WBT-D-3769 NP-Enclosure

**Common Q PAMS Secure Development and Operational Environment
SSER 23 Appendix HH Action Item 98 Requests for Additional
Information**

Watts Bar 2

EDCR COVER SHEET

DESCRIPTION OF CHANGE

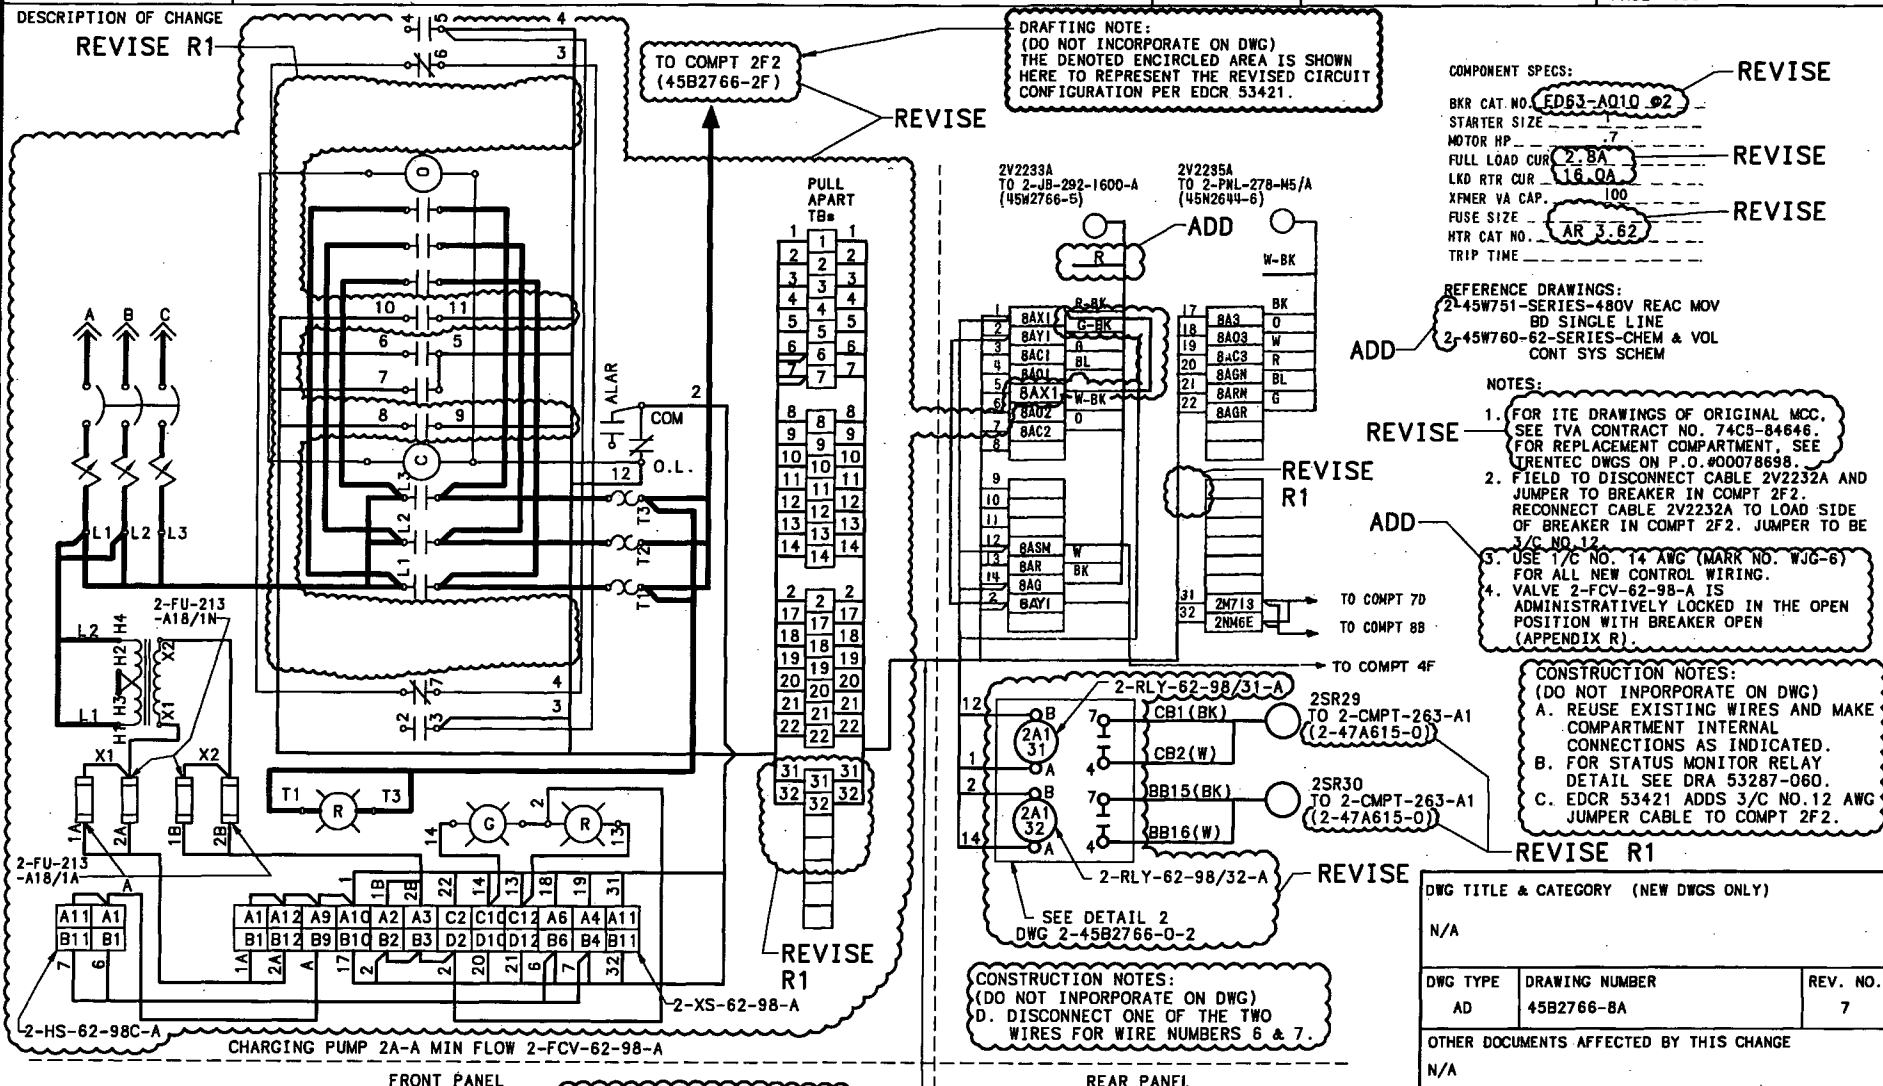
REVISE R1

DRAFTING NOTE:
(DO NOT INCORPORATE ON DWG)
THE DENOTED ENCIRCLED AREA IS SHOWN
HERE TO REPRESENT THE REVISED CIRCUIT
CONFIGURATION PER EDCR 53421.
